MFN 08-168

Subject: **Response to Portion of NRC Request for Additional Information Letter No. 141 Related to ESBWR Design Certification Application – RAI Numbers 7.1-75, 7.1-76 and 7.1-79**

**Response to Portion of NRC Request for
Additional Information Letter No. 141 Related to
ESBWR Design Certification Application –
RAI Numbers 7.1-75, 7.1-76, and 7.1-79**

Figure 1

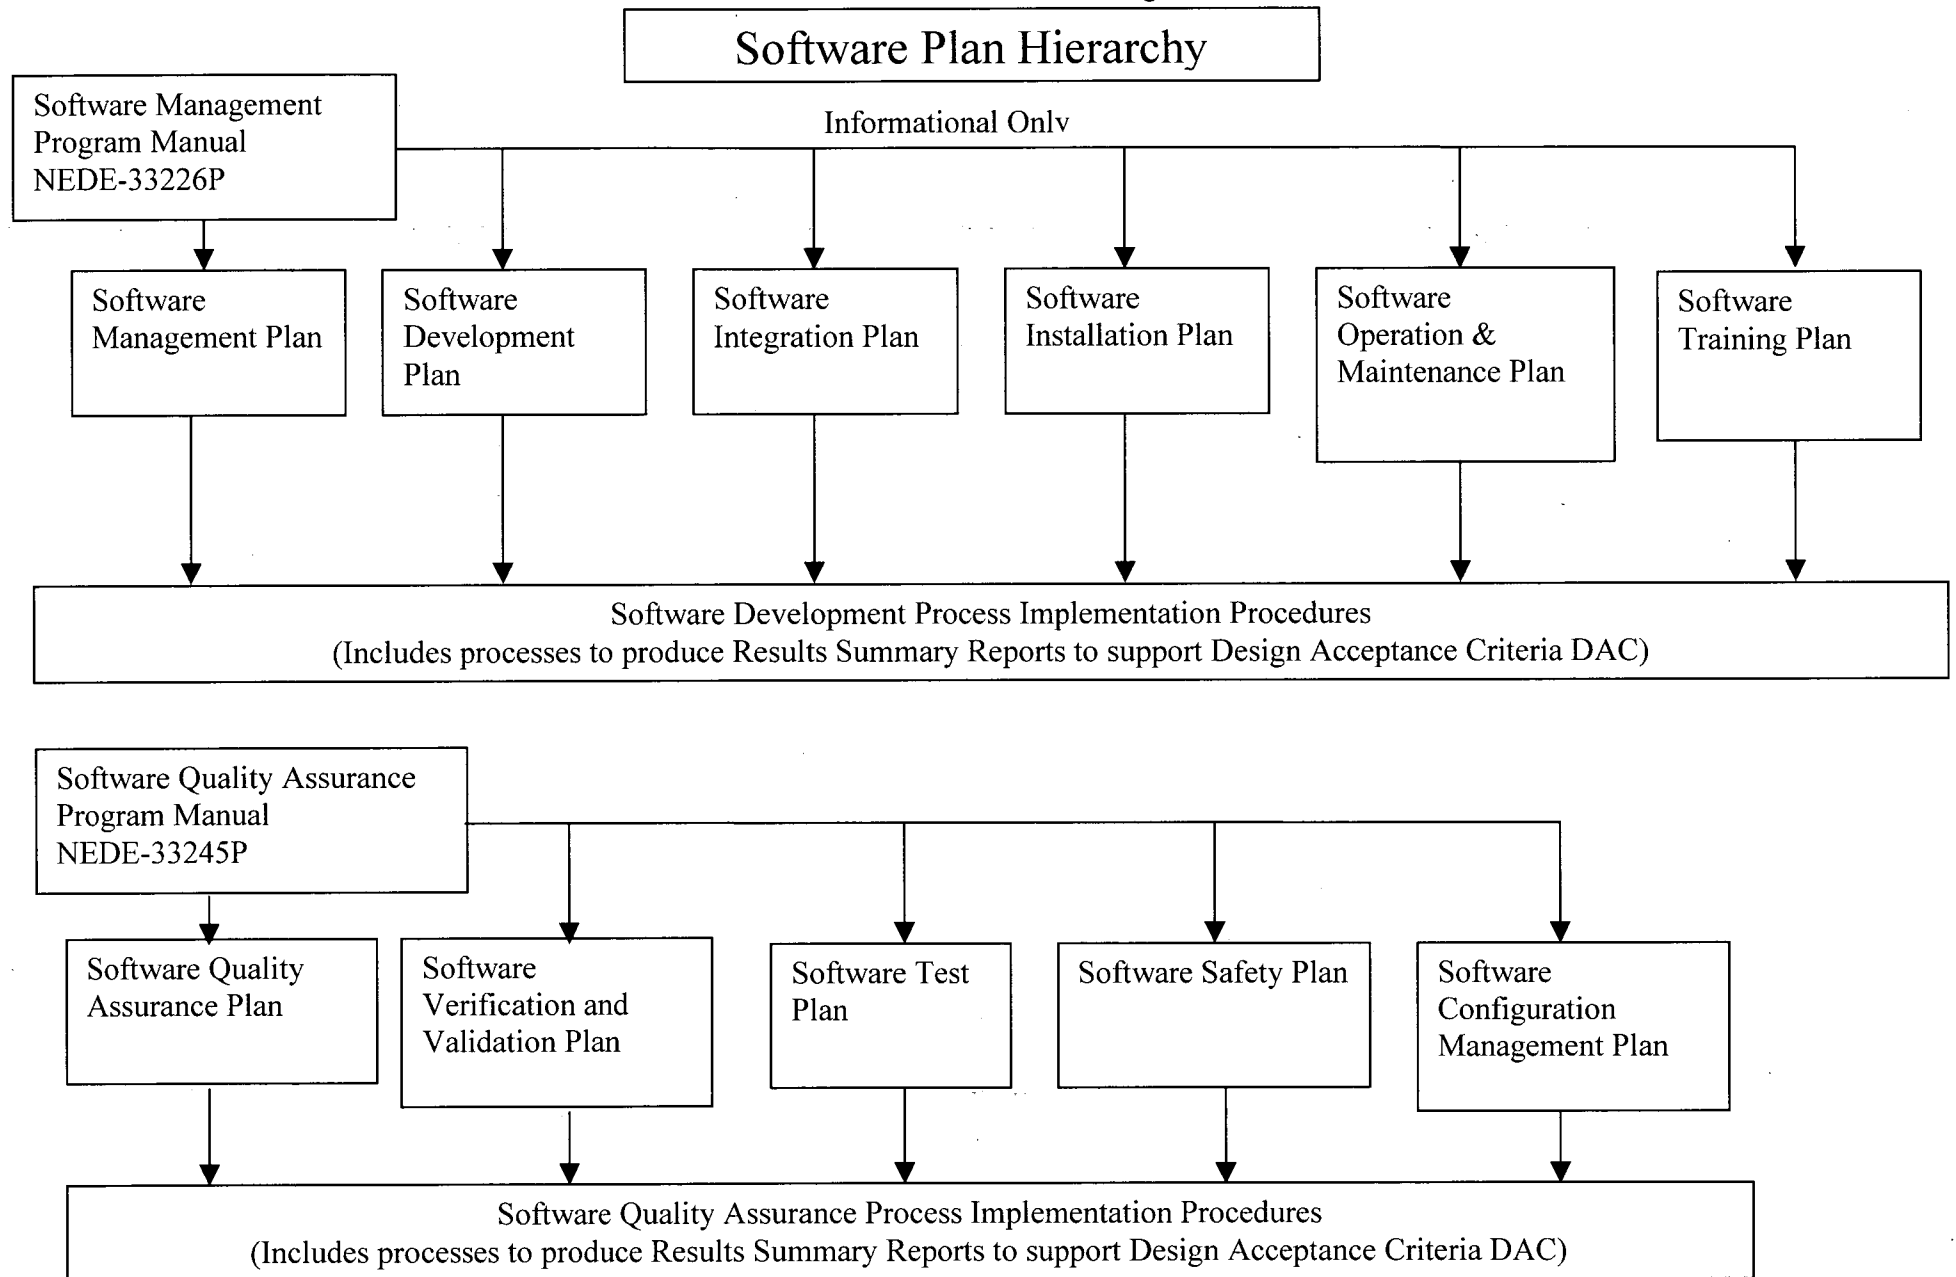
Staff understands that GEH intends the submitted SMP and SQAP to be umbrella or template type documents. The submitted LTRs provide high level planning information (i.e. roadmap) and describe the process that GEH will use to develop / approve the various software systems and applications needed for ESBWR. It is the staff's understanding that these are not "implementation plans". Please confirm staff's understanding of the documents' purpose, and provide additional clarification of the purpose in the LTRs.

In addition, the names of these two LTRs correspond to names specified in Branch Technical Position 7-14 (BTP 7-14) - both the current revision and the previous revision. However, the LTRs have different purpose from that intended by the BTP. The BTP 7-14 documents are part of a set of documents; while the LTR documents actually include these other BTP 7-14 referenced documents as their constituent parts. Please rename these LTRs to more precisely reflect their use as templates or process descriptions in order to reduce the potential for confusion or misunderstanding. Also, please confirm that the implementation plans, when developed, will follow the same document flow (i.e., SMP and SQAP encompassing all the BTP 7-14 referenced documents for specific implementations.)

The Submitted License Topical Reports (NEDO-33245 and NEDO-33226) contain high level planning documents for the ESBWR software development and quality assurance processes. These are not implementation procedures. Implementation procedures will be developed as subordinate documents to these plans. The implementation procedures will be written once the NRC approves the LTRs. As such, the LTRs will be in full compliance with the governing plans. The purpose of the subject License Topical Reports is to provide a traceable and verifiable licensing basis for the development of implementation procedures that will be used for the development and maintenance of all ESBWR class Q, N3, and N2 software applications.

The Names of the subject Software License Topical Reports will be changed as follows; LTR NEDO-33245 ESBWR I&C Software Quality Assurance Plan will become the ESBWR I&C Software Quality Assurance Program Manual and will contain the following Plans;

LTR NEDO-33226 ESBWR I&C Software Management Plan will become the ESBWR I&C Software Management Program Manual and will contain the following plans;

Figure 1 (next page) represents the hierarchal structure of these documents and shows the intended implementation path forward. This figure is informational only and will not be included in the subject LTRs.
